**Rezone, General Plan Amendment, Community Plan, Master Development Agreement
Mt. Saratoga
Thursday, July 28, 2016
Public Hearing**

Report Date: Thursday, July 21, 2016
 Applicant: Edge Homes, LLC
 Owners: DCP Saratoga LLC, Capital Security Mortgage, Jan Wilkins, Mt Saratoga LLC
 Location: ~1200-1900 West, between Pony Express Parkway and SR 73
 Major Street Access: State Road 73, Pony Express Parkway
 Parcel Number(s) & Size: Size: ~688 acres
 580330243, 580330329, 580330208, 580330328, 580330288,
 580340442, 580340289, 580340347, 580340312, 580340313,
 580340360, 580340441, 580340359, 580340355, 580340372,
 580340333, 580340357, 580340323, 580340324, 580340340,
 580340341, 580340230
 Parcel Zoning: R-3
 Adjacent Zoning: R-3, RR, RA-5
 Current Use of Parcel: Vacant
 Adjacent Uses: Residential, Agricultural, undeveloped
 Previous Meetings: PC Work Session 1/14/16
 CC Work Session 2/2/16
 Previous Approvals: None
 Land Use Authority: City Council
 Type of Action: Legislative
 Future Routing: Public Hearing with City Council
 Author: Sarah Carroll, Senior Planner

Planning Commission Staff Report

Type of Item: Community Plan, General Plan Amendment &
Rezoning, Master Development A

MT. Saratoga
 EXHIBIT 13 - CULINARY WATER MASTER PLAN

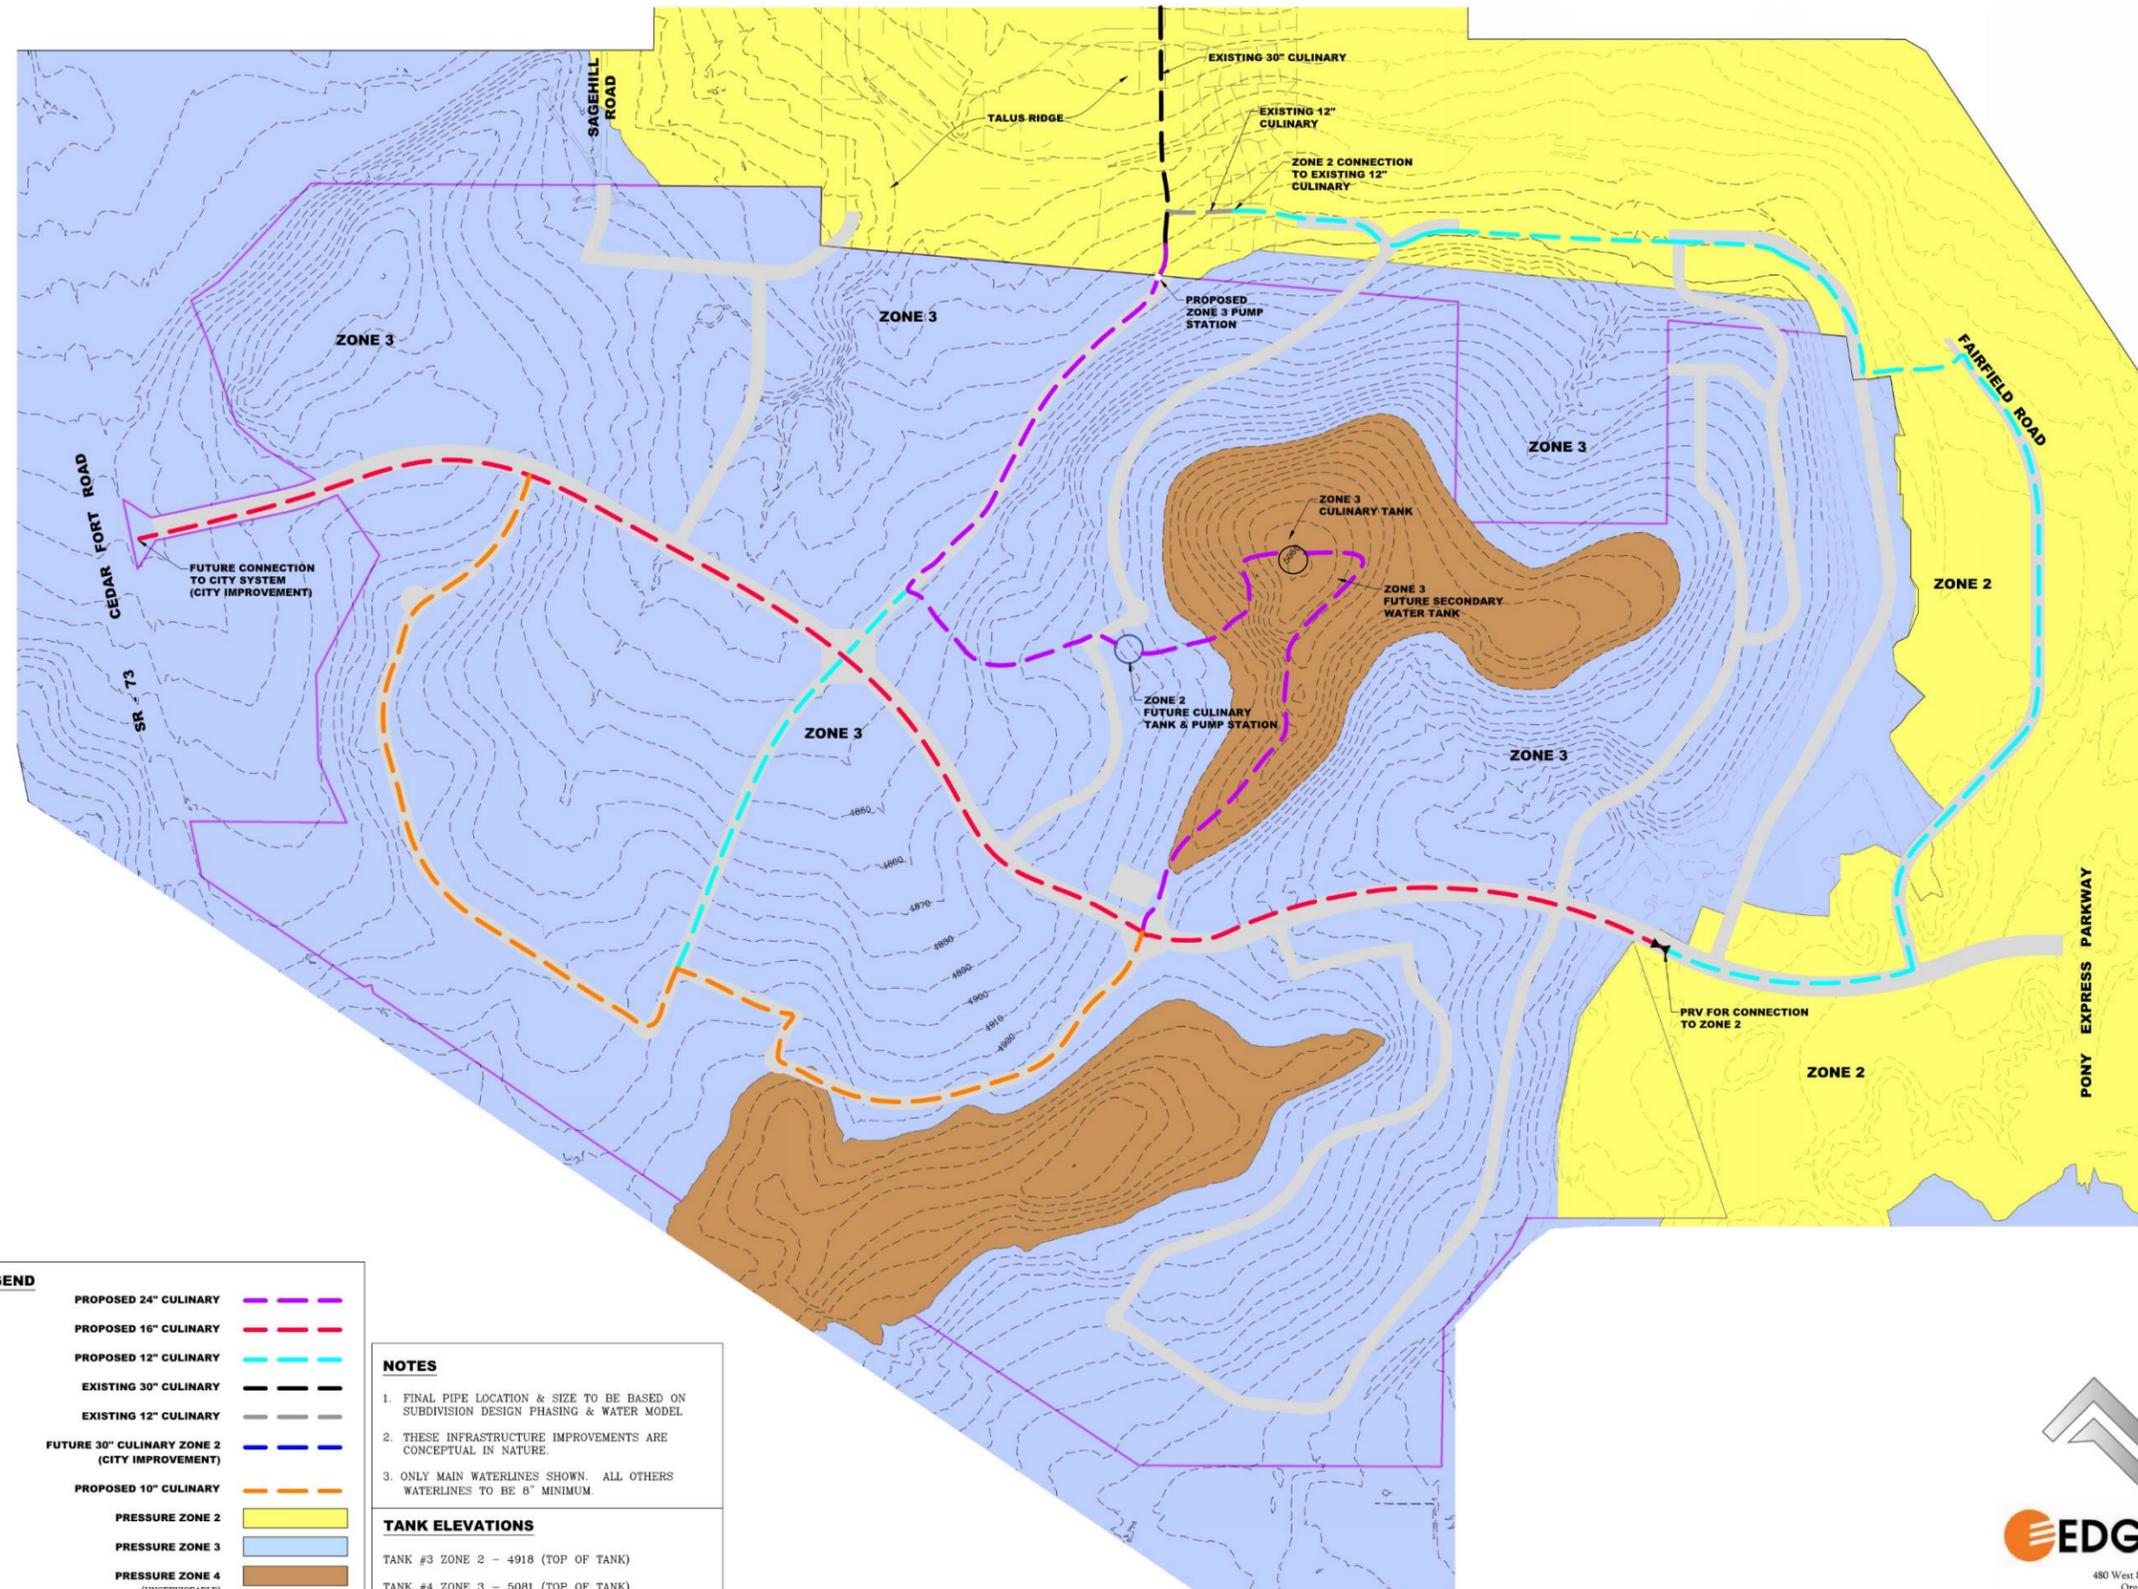
- A. Page 29 of the Community Plan – The number of connections shown in the table is greater than the number assumed in the master plan.
- B. Page 31 of the Community Plan – Show the existing 16-inch pipeline on the east side
- C. Meet all engineering conditions and requirements in the construction of the subdivision and recording of the plats. Review and inspection fees must be paid as indicated by the City prior to any construction being performed on the project.
- D. All review comments and redlines provided by the City Engineer are to be complied with and implemented into the Final plat and construction drawings.
- E. Developer must secure water rights as required by the City Engineer, City Attorney, and development code.
